ONE SYDNEY HARBOUR

BARANGAROO SOUTH

STAGE 1B - Building R4B

SECTION 4.55

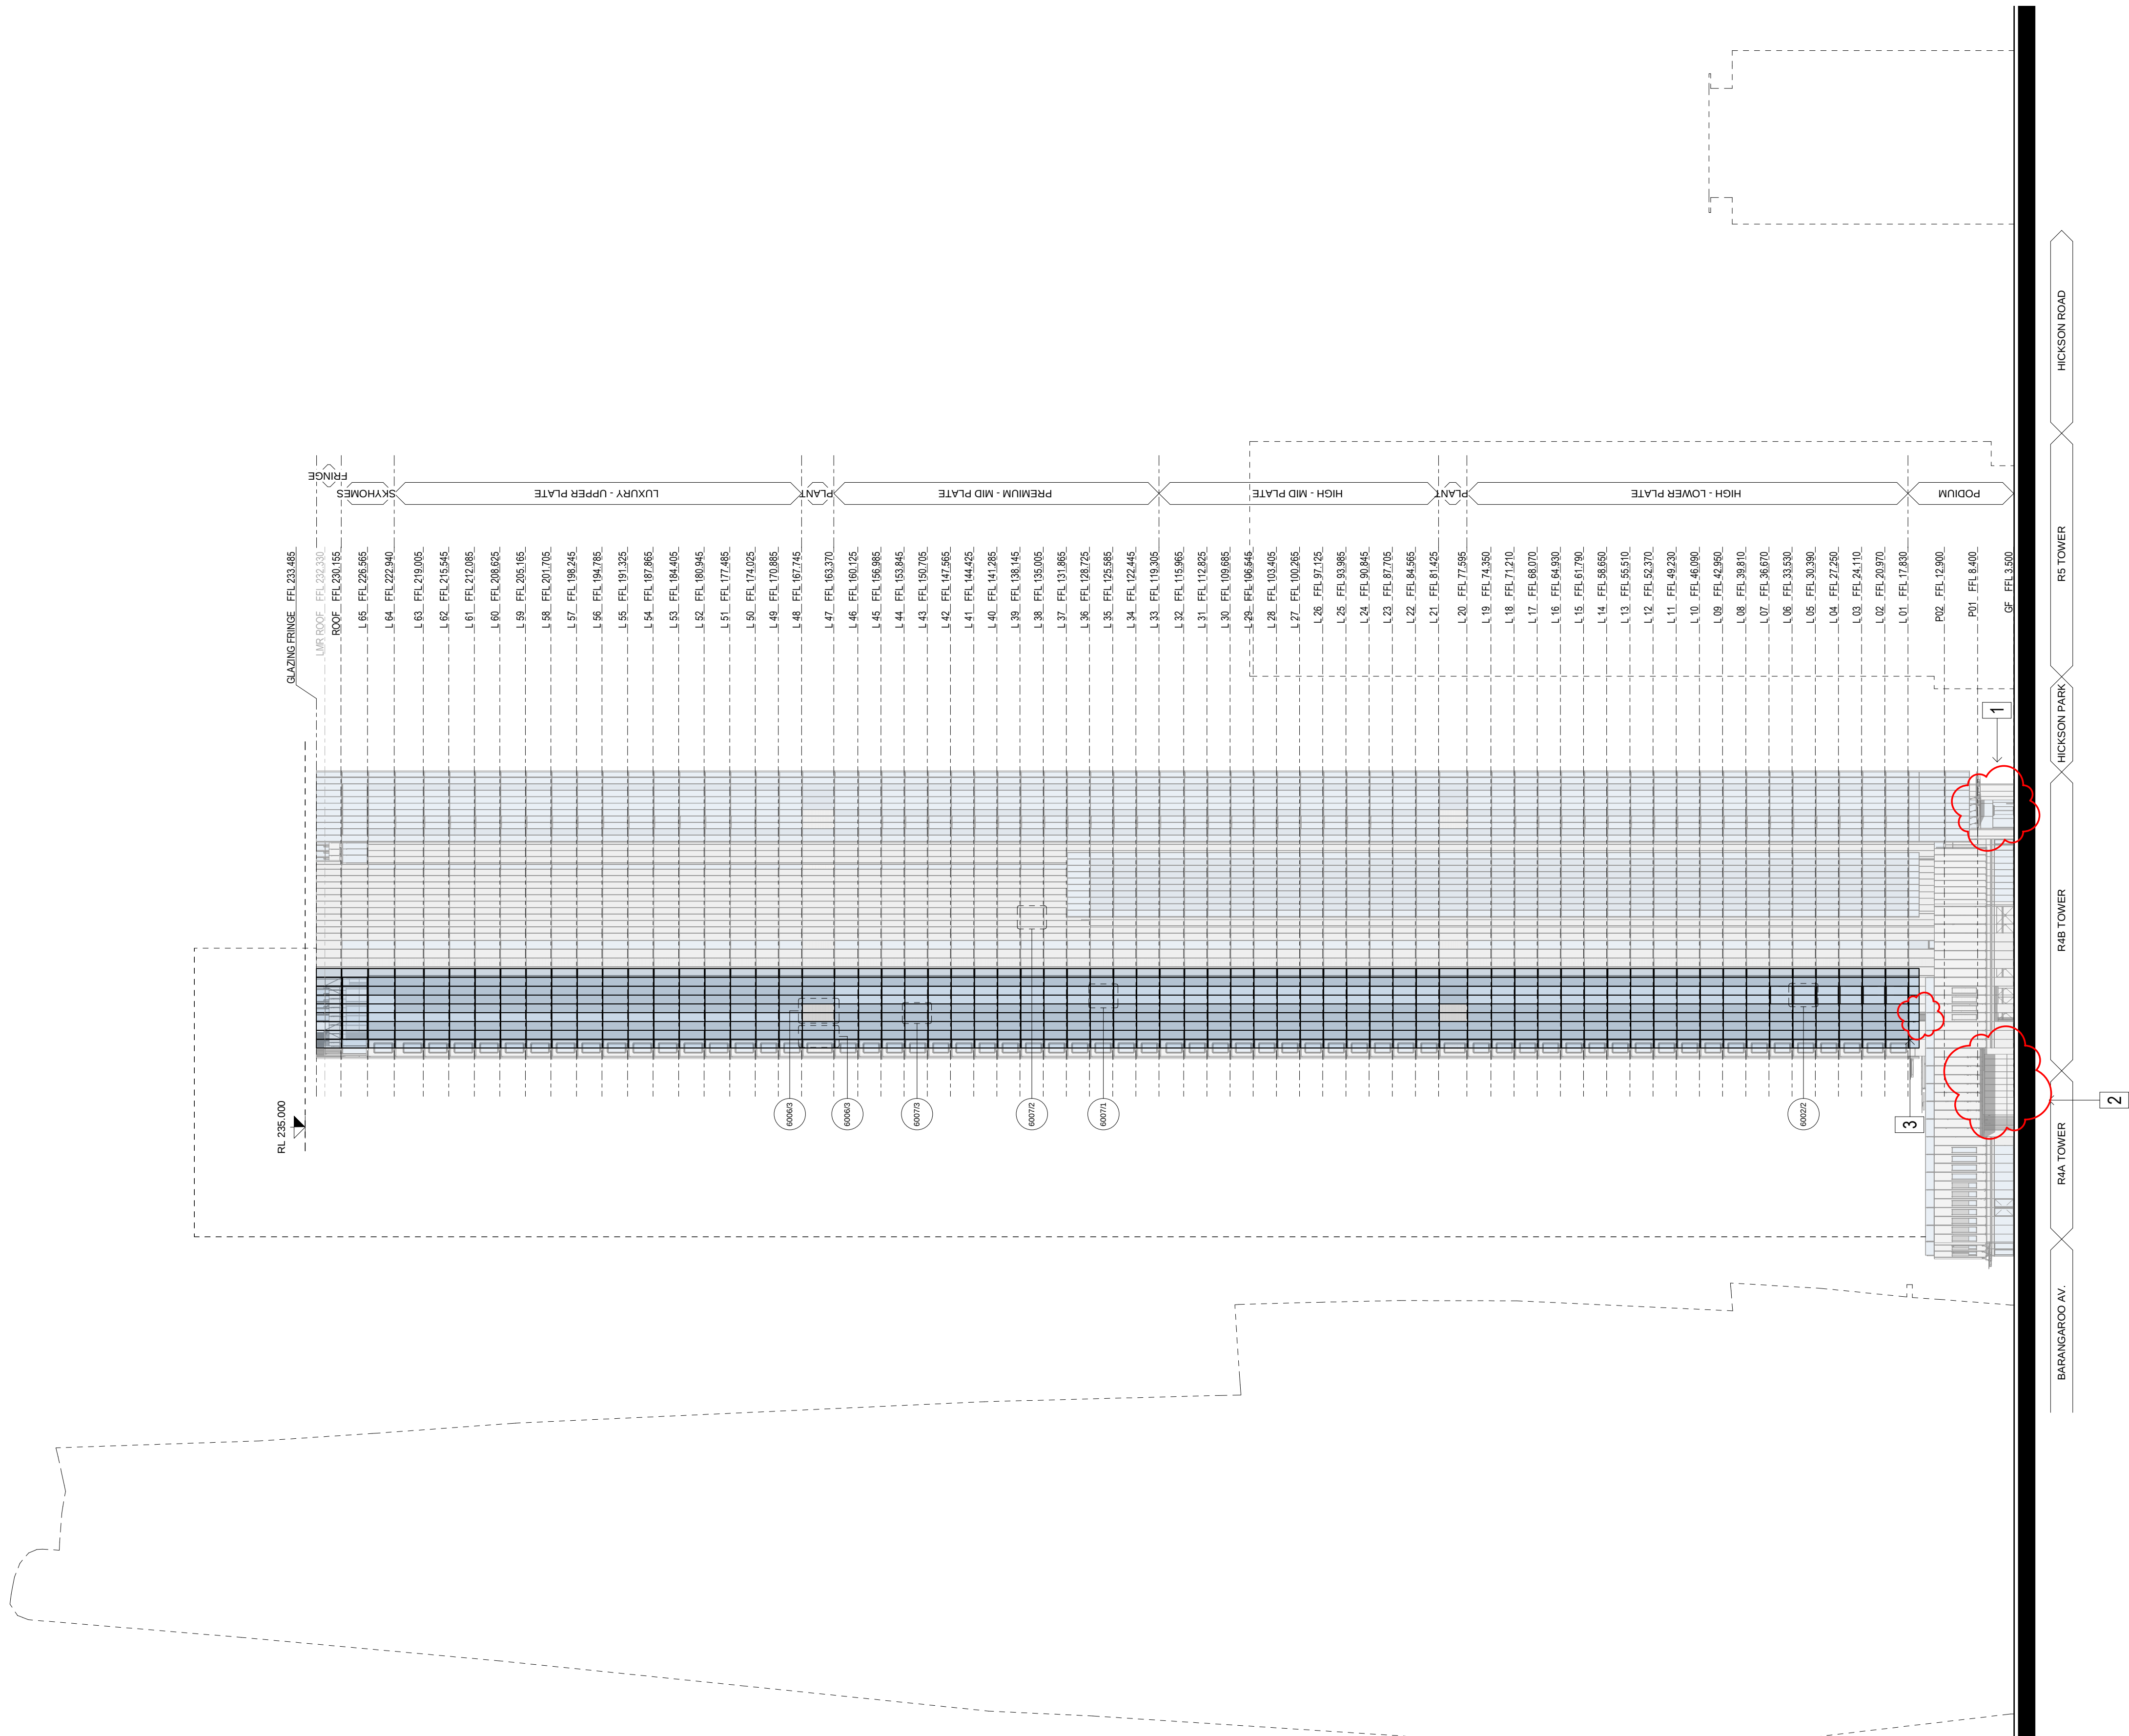
1. UPDATED ENTRY VESTIBULE DESIGN
2. UPDATED CARPARK ENTRANCE
3. UPDATED SKIRT DESIGN AND PORTAL DIMENSION

1 Bridge_Elevation North-East
1:75

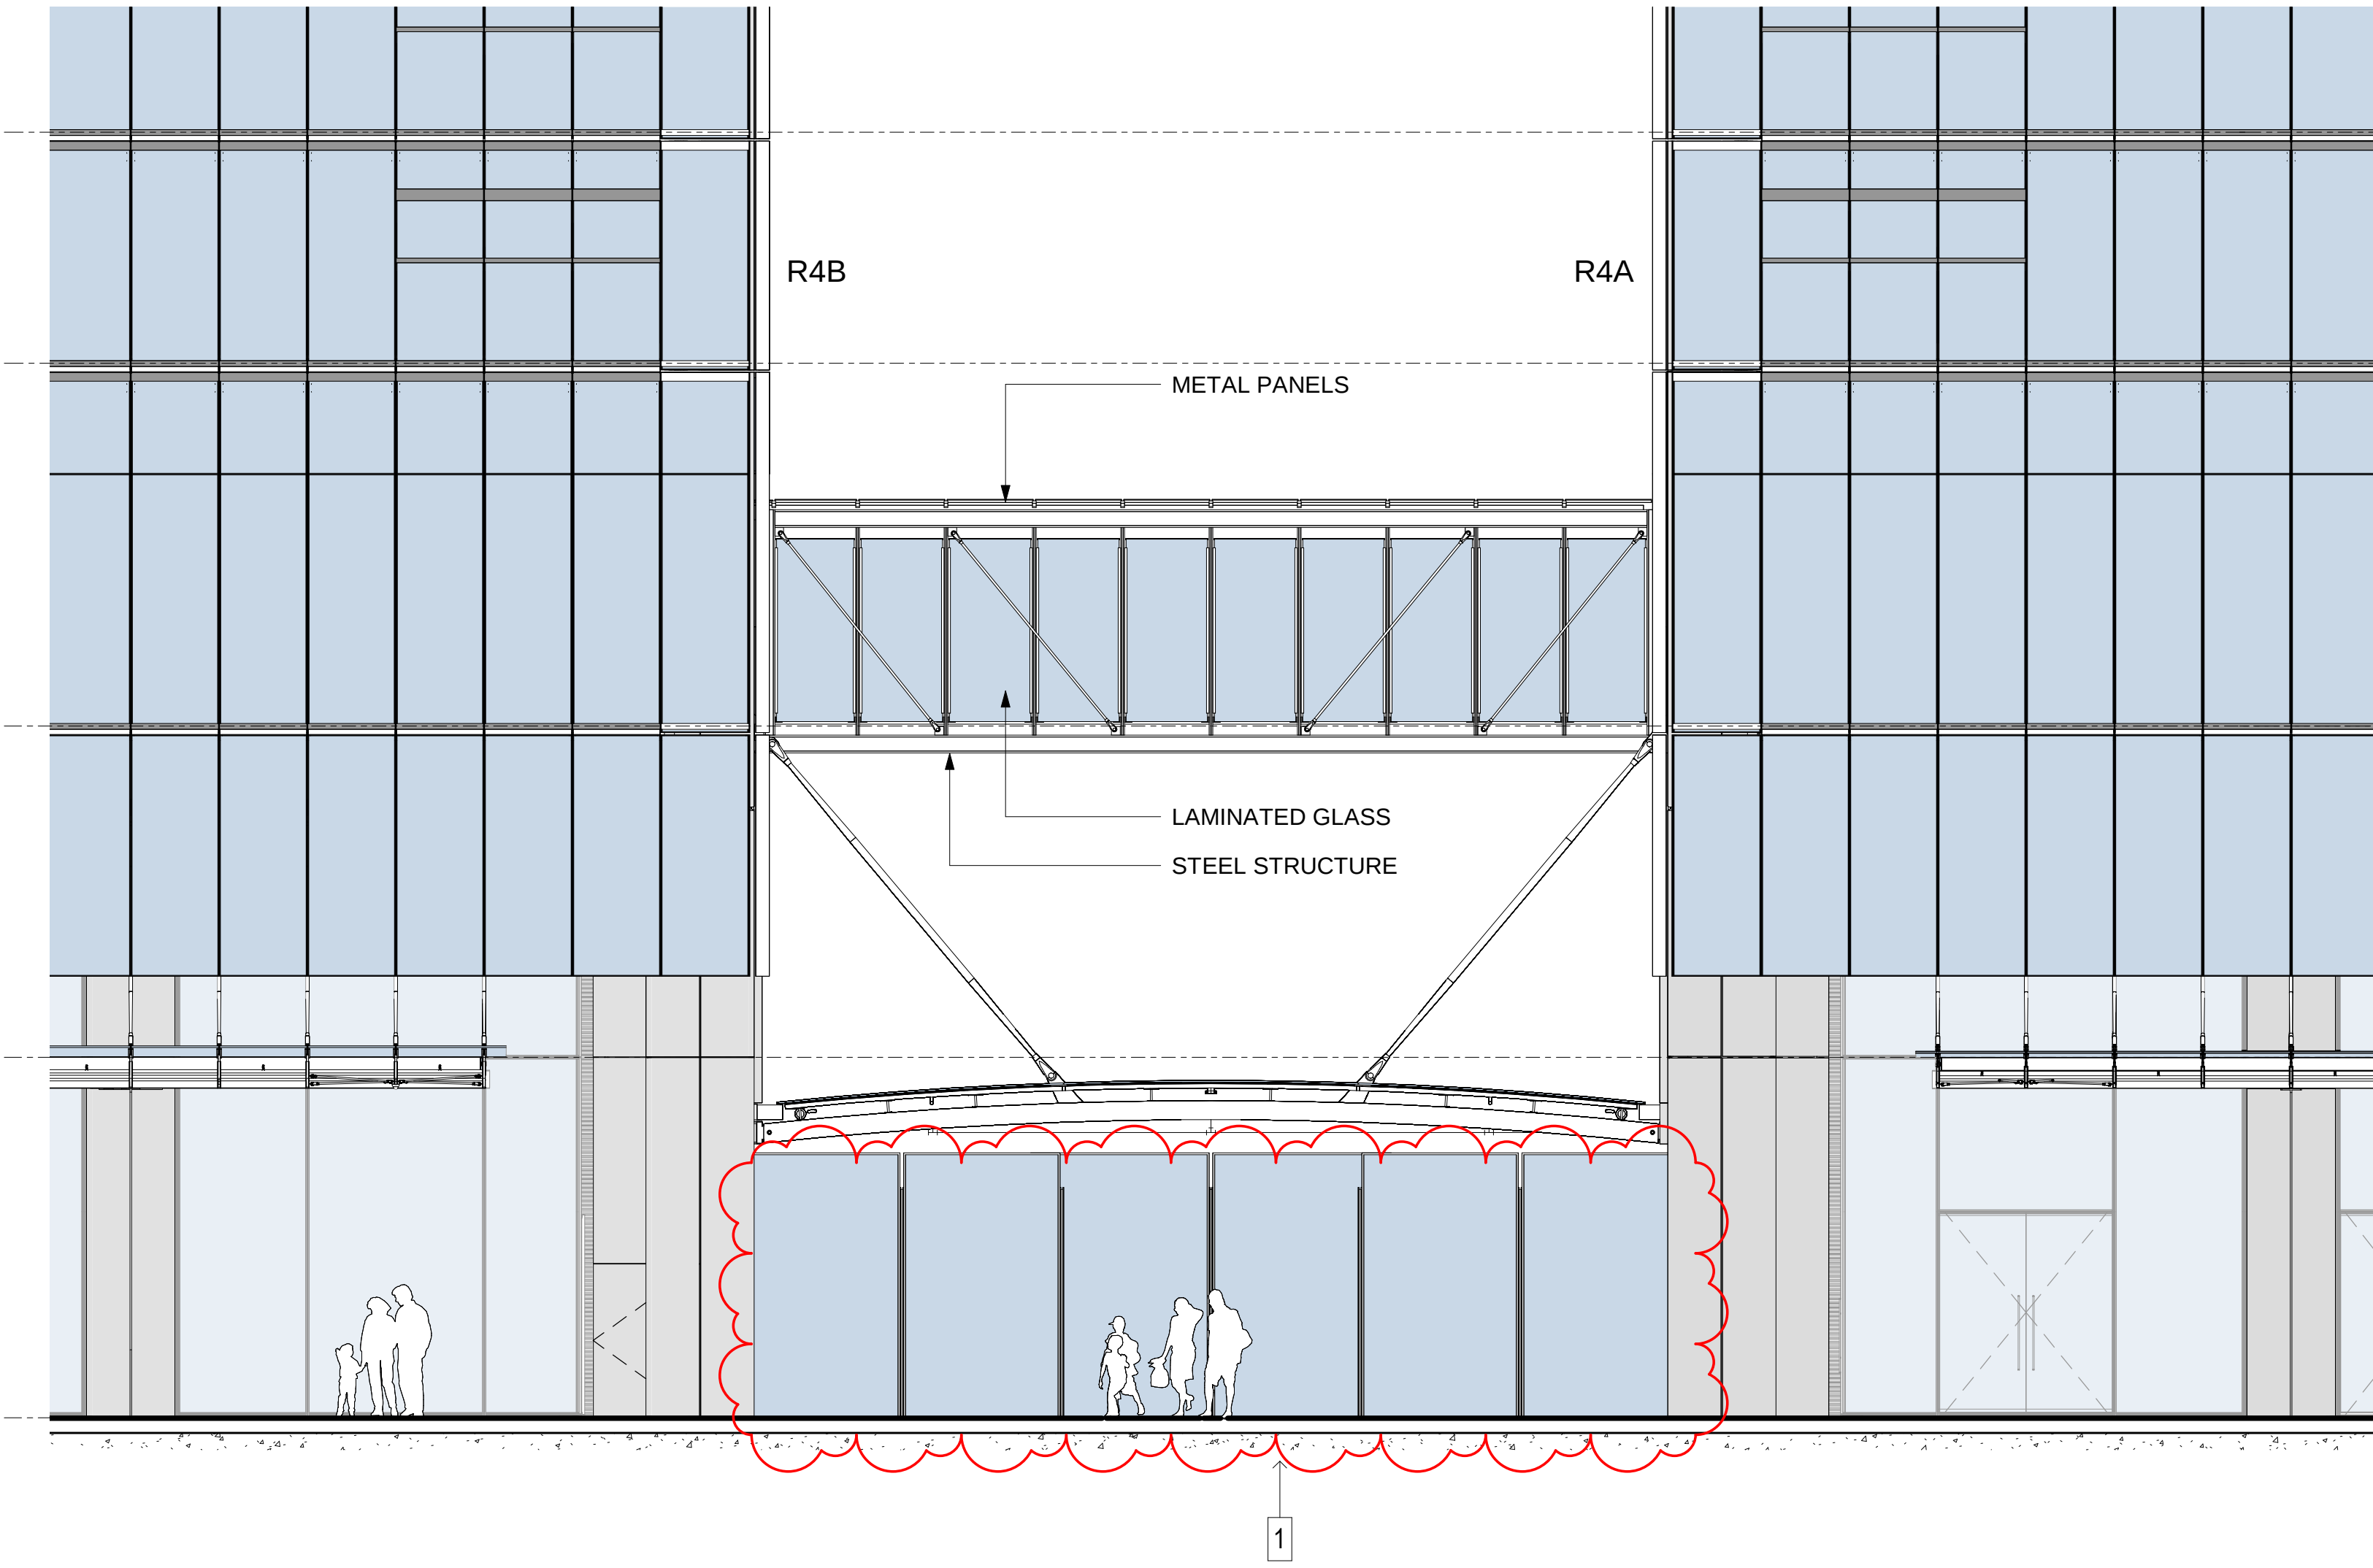
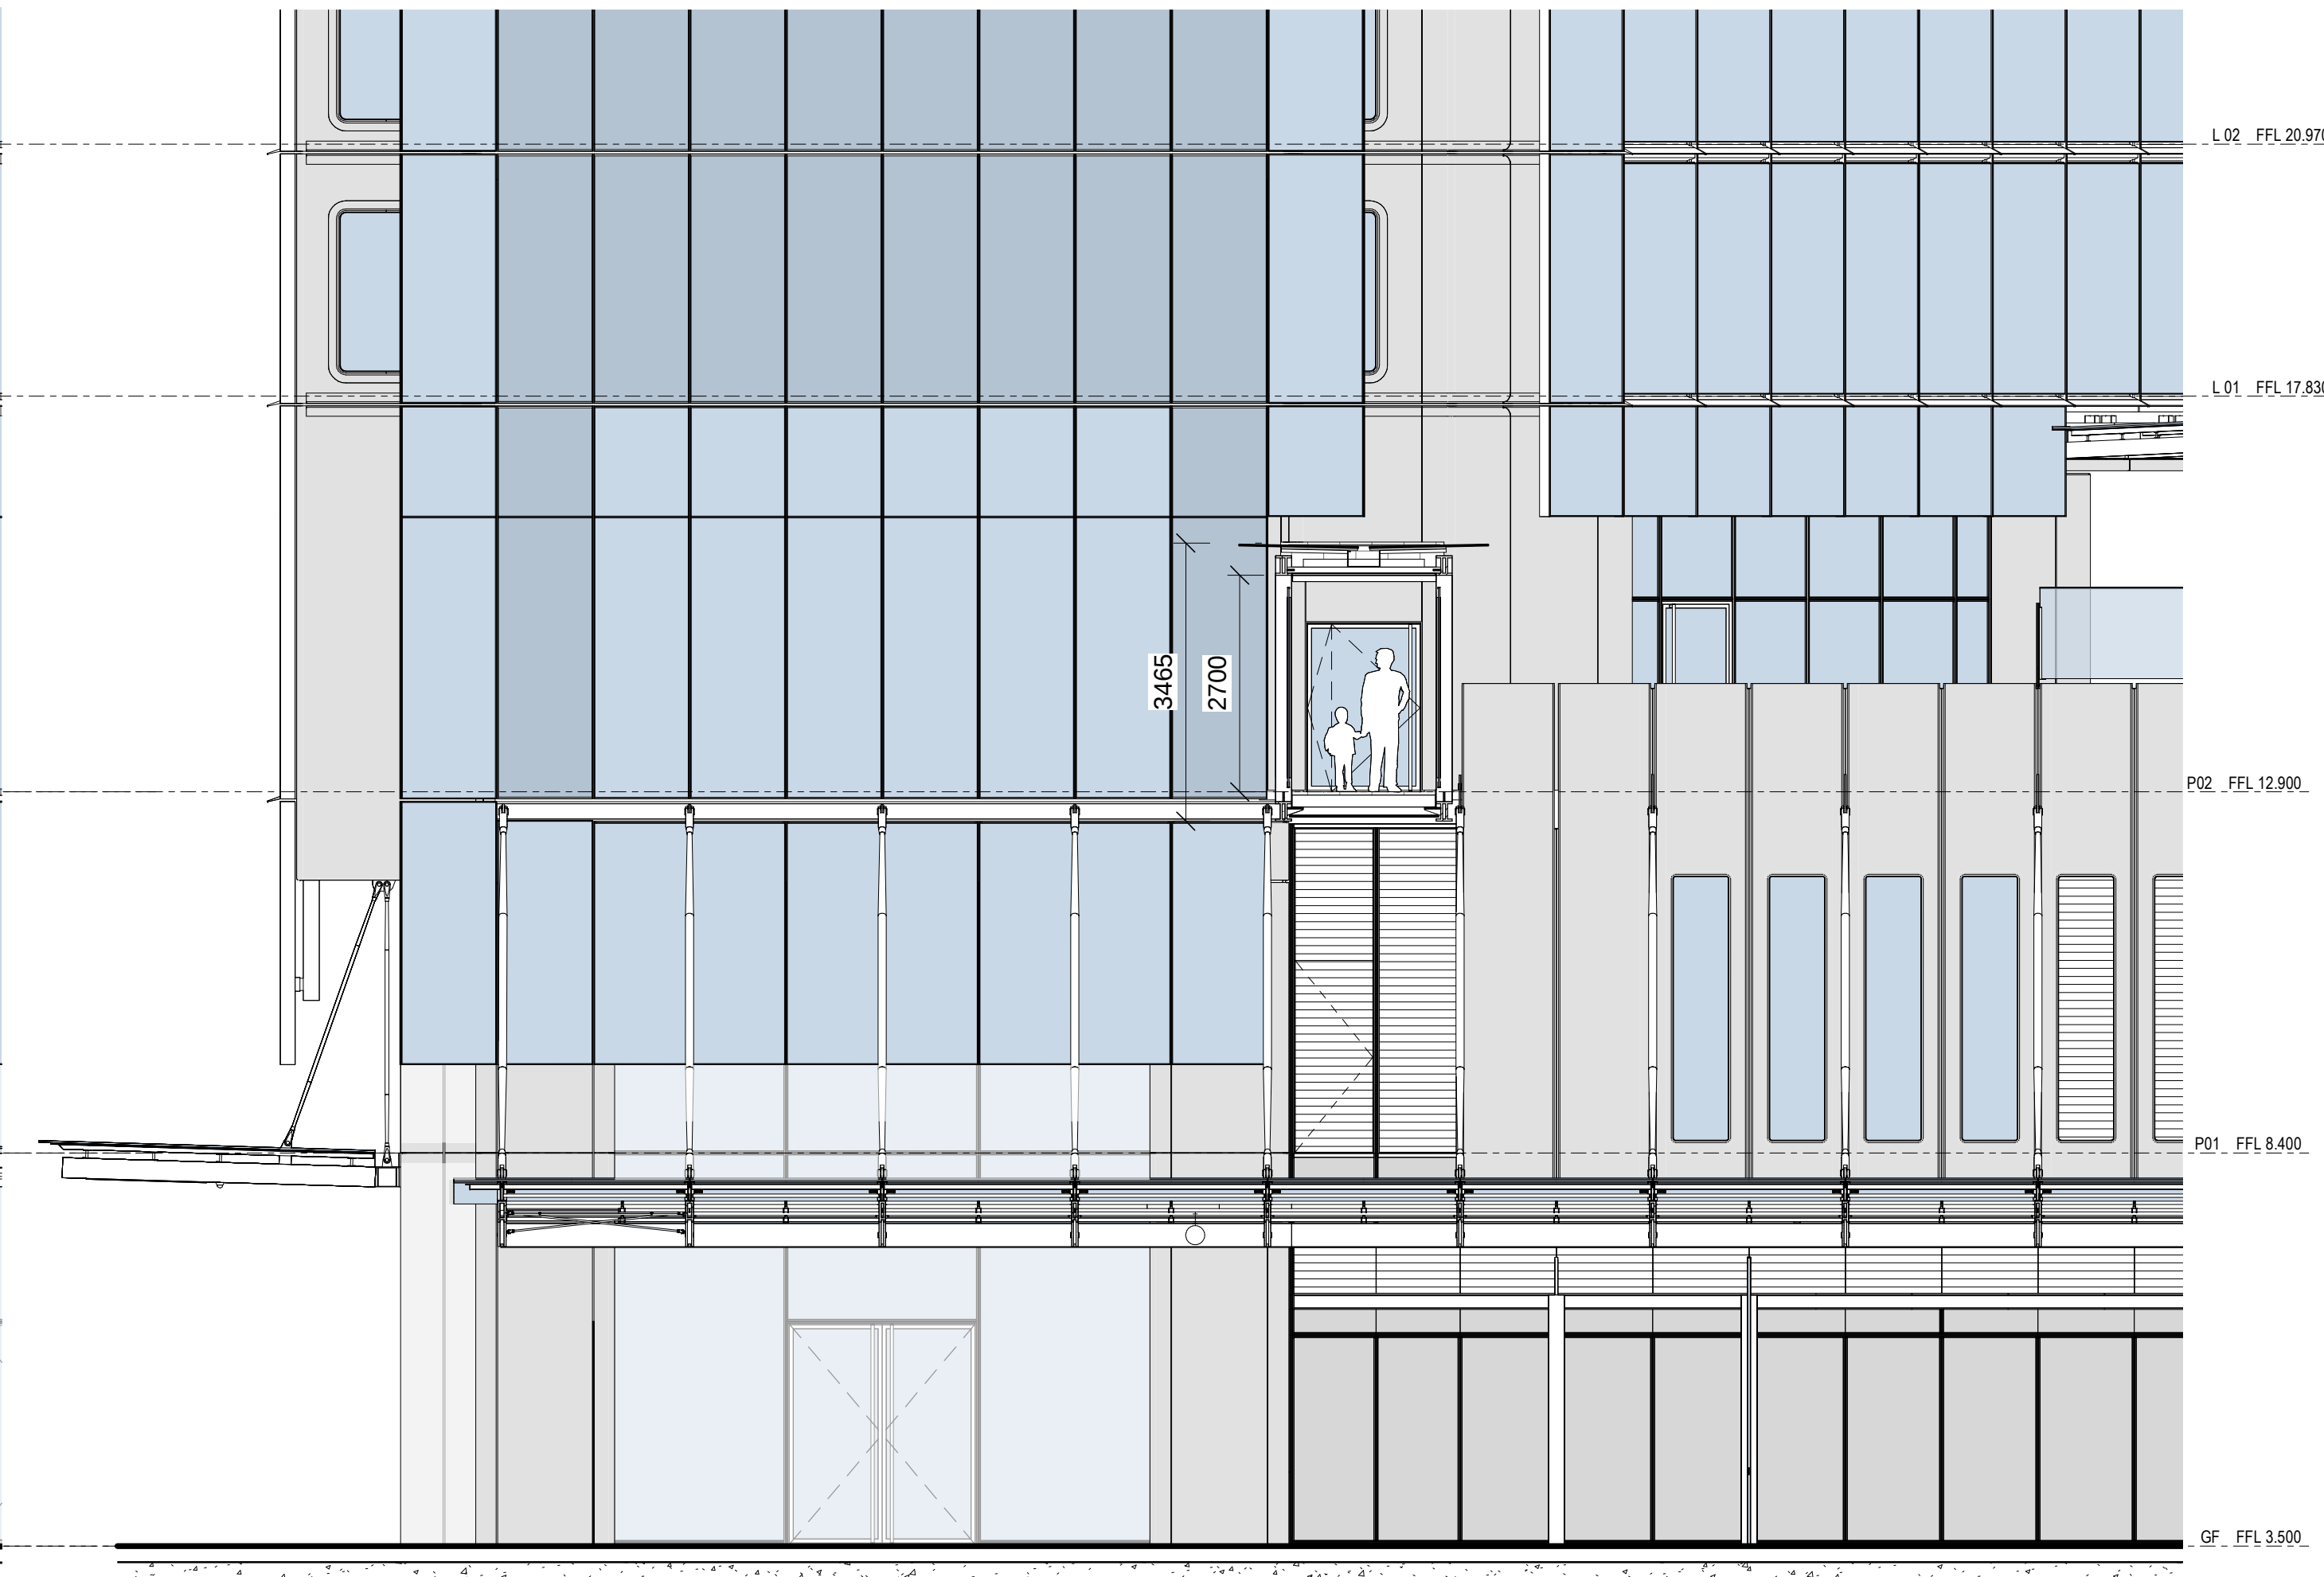
1. STRADA WIND BAFFLES PER SECRETARY APPROVAL
